Part 21 (PAR)

PART 21 REPORT - DEVIATION OF HK CIRCUIT BREAKER CLOSE LATCH SPRING

**Subject: Amendment to Previous 10CFR Part 21 Notification of Deviation re. HK Circuit Breaker
Close Latch Spring**

Figure 1 - Closing Latch Spring

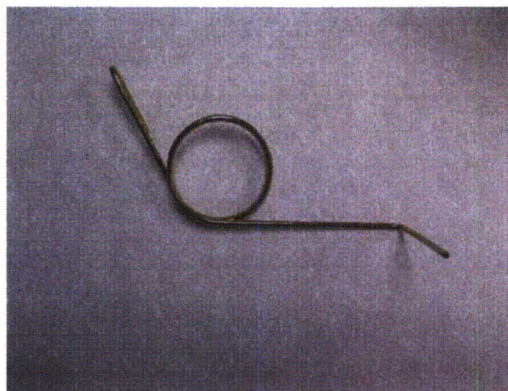
4. Nature of the deviation: The close latch springs provided during the reported time period have acceptable dimensional, material type and finish critical characteristics; however a sampling of springs were found to be as much as 34% lower initial moment and as low as 18% lower final moment relative to the nominal requirements of the master drawing. There is a potential for an aged HK circuit breaker with hardening grease (towards the end of the ABB 10-year recommended maintenance periodicity) and this reduced spring force not to close when commanded. No field failures or shop failures of this closing latch spring have been identified.

- f. Revised part number 162374A00 spring drawing to revision 8 to include a larger free position angle. (Action complete)
 - g. Notified all customers affected from January 2010 to present. (Action Complete)
